Built Heritage, Townscape and Visual Addendum Report

Great Ormond Street Hospital
Children's Cancer Centre (GOSH)

October 2022

Figure 1.1: Illustrative diagram showing estimated extent of roofscape elements extending above Landmark Viewing Corridor from Assessment Point 4A.1

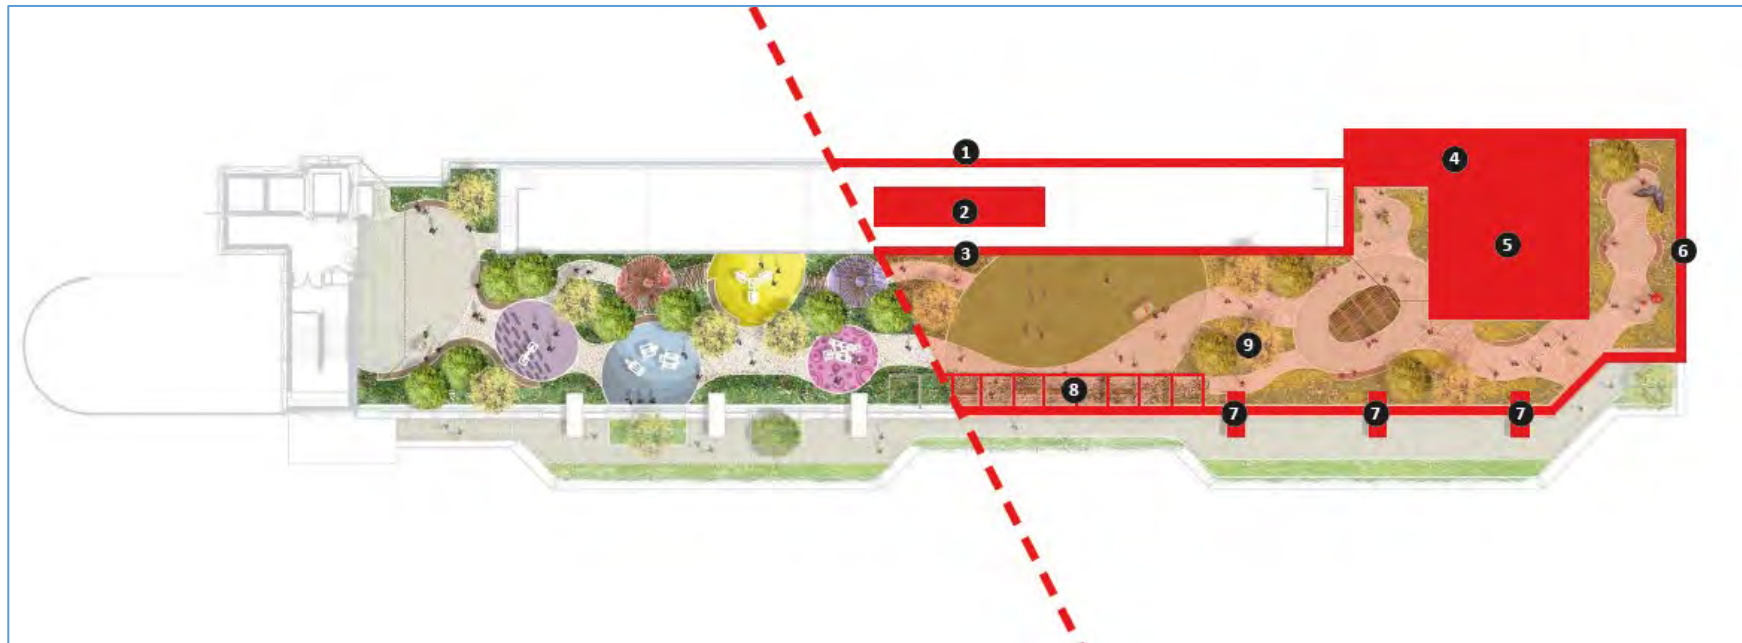
- 1.5 The Proposed Development, as originally submitted, incorporates some architectural elements, which would extend above the threshold height of the Landmark Viewing Corridor from Assessment Point 4A.1 (**Figure 1.1**):
 - 1. Perforated screen concealing external plant.
 - 2. Externally mounted Air Source Heat Pumps.
 - 3. Acoustic wall separating plant from roof garden.
 - 4. Covered fire escape stair enclosure (Level 10-Level 9) – part of the 'Eastern Core' for the purposes of this report.
 - 5. Eastern lift core and lobby incorporating smoke clearance shaft and garden store.
 - 6. Perimeter edge railings (protection).
 - 7. Chimneys containing building services.

- 1.7 As confirmed in the Hayes Davidson technical analysis at **Appendix 1**, the eastern lift core and lobby, covered fire escape stair enclosure and acoustic wall are the most significant elements (in relative terms) in the LVMF views, albeit they are not readily legible in terms of the panorama view. They are, however, more apparent in the 600% zoomed in version of those visualisations. The eastern lift core and lobby and the covered fire escape stair enclosure elements have been the focus of revisions to the Proposed Development.

Figure 1.2: Original Scheme (Left) and Revised Scheme (Right)

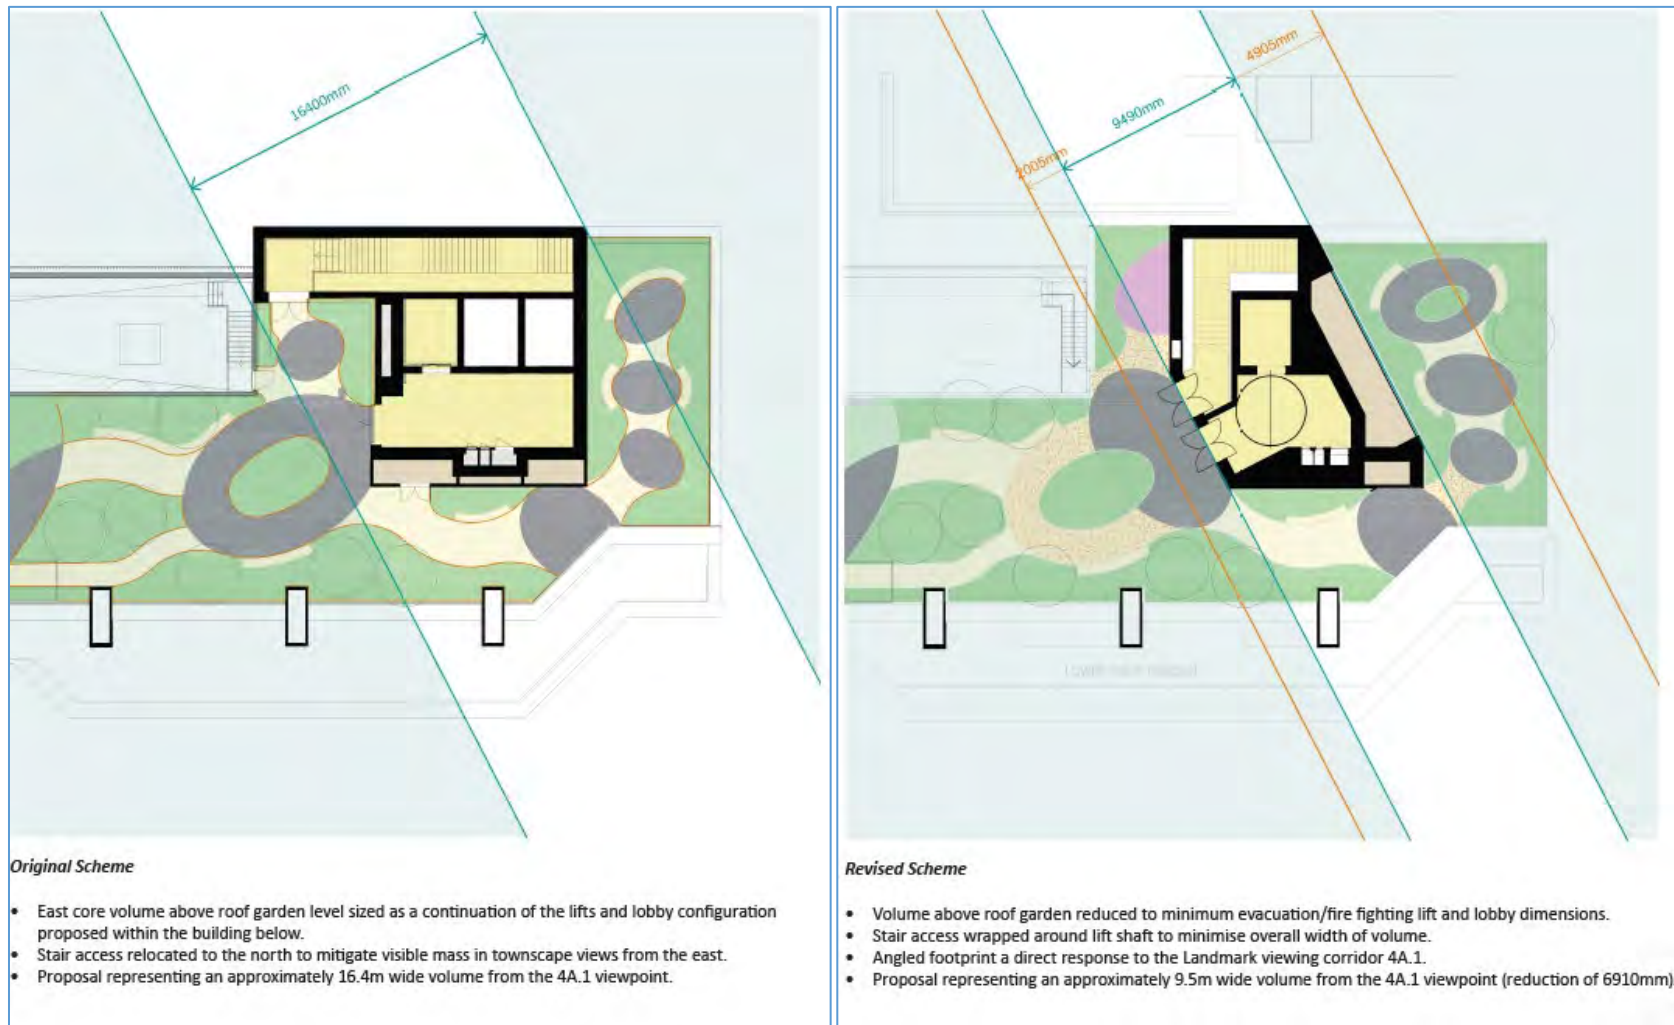
- 1.9 This Addendum Report provides a considered view of the impacts and implications for the following scenarios:
 - **Original Scheme:** The Proposed Development as submitted for the sake of completeness (**Figure 1.2**).

- **Revised Scheme:** the revised Proposed Development incorporating amendments to the proposed roofscape that reduces the perceived impacts on LVMF views, with a focus on View 4A.1, through a re-design of the eastern core whilst maintaining the optimum functionality of the roof garden (**Figure 1.2**).

Appendix 1: Hayes Davidson – Accurate Visualisations

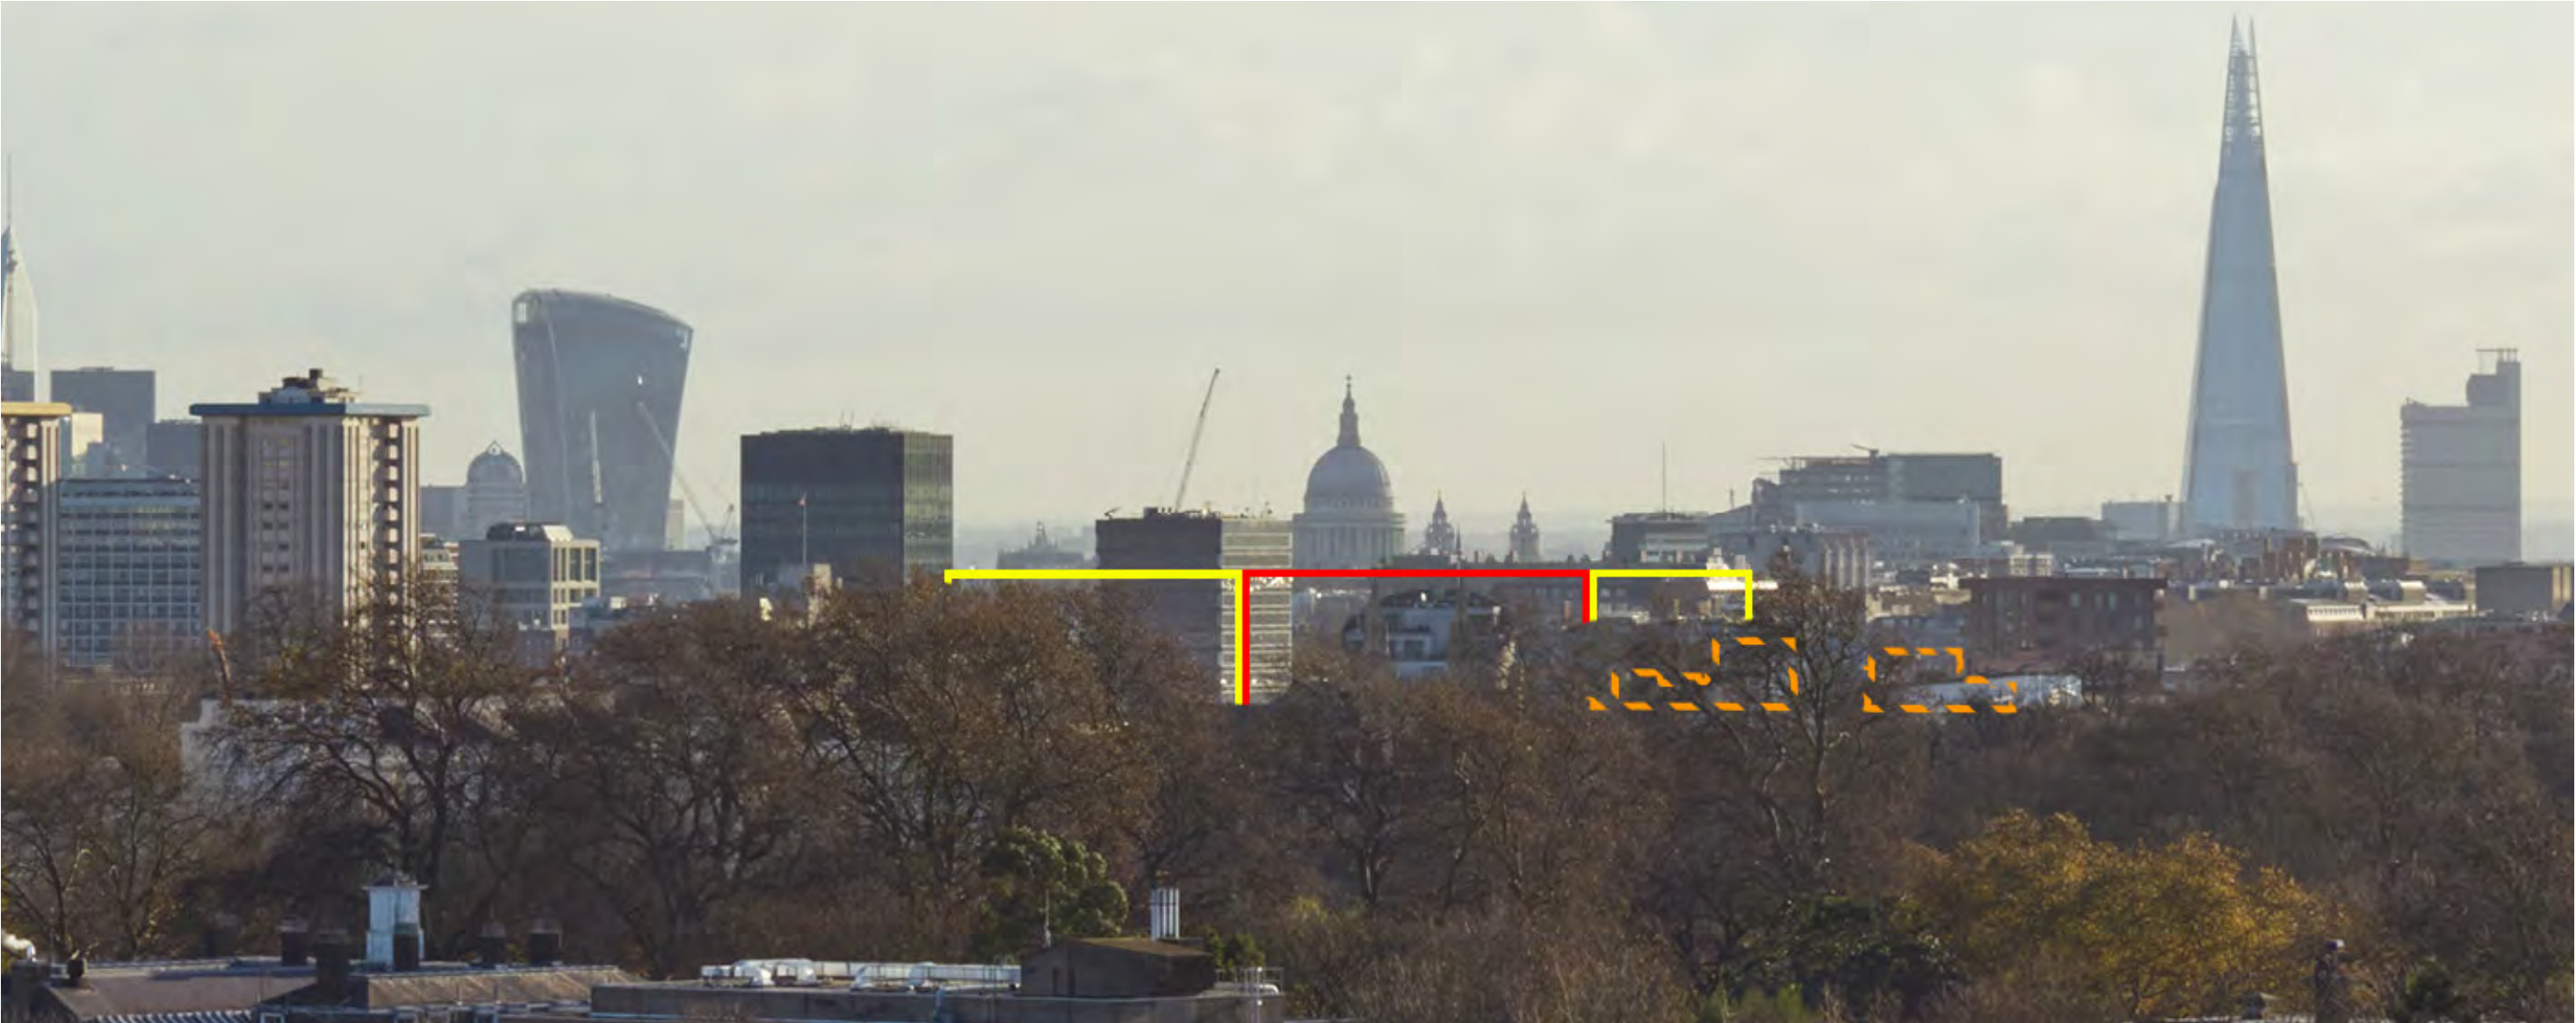
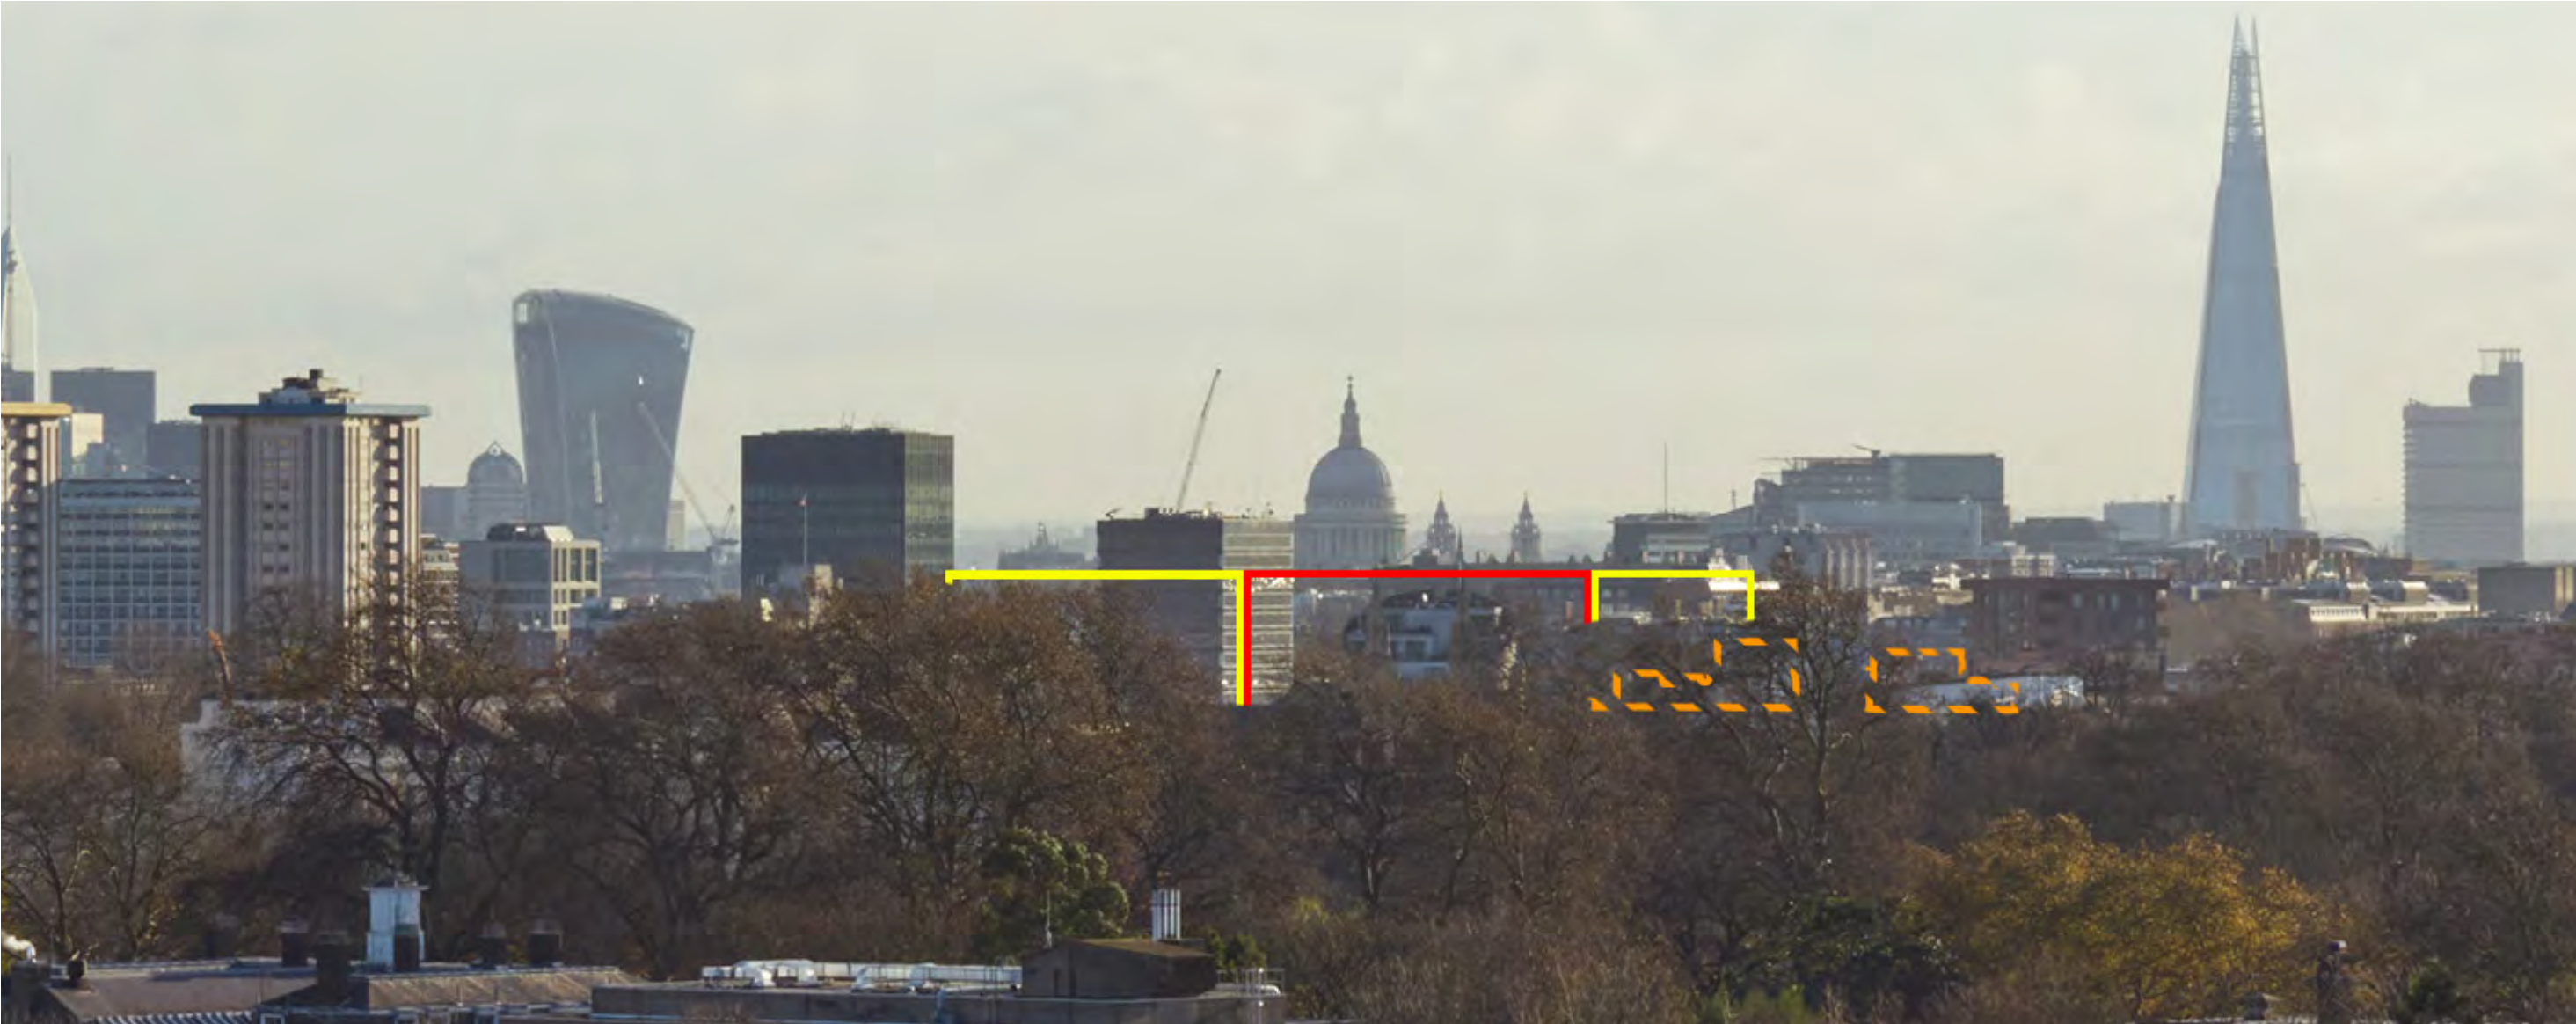
- 2.21 When viewed with a magnification of 600% it is possible to see more clearly these elements, which exceed the threshold plane. Some of these would extend above the Protected Silhouette of the Landmark Viewing Corridor, with the eastern core and acoustic wall creating the greatest change. These elements would

- 2.24 The Revised Scheme includes a much reduced eastern core, which pulls this element away from the peristyle of St Paul's Cathedral in the view from Primrose Hill, with the geometry aligned with the viewing corridor. In the magnified image at 600 % zoom (**Appendix 1**), the Revised Scheme would reveal a greater proportion of the silhouette of the western towers of St Paul's Cathedral. The acoustic wall would still extend above the threshold, marginally, but would not result in a perceptible impact on the silhouette of St Paul's Cathedral (Strategically Important Landmark).

- 2.25 The magnified image at 600% zoom confirms that the Revised Scheme would maintain a gap between the drum and north western tower by moving the massing away from the front of the peristyle of the drum in the view, thereby maintaining the legibility of the peristyle and drum as separate elements within the overall composition.
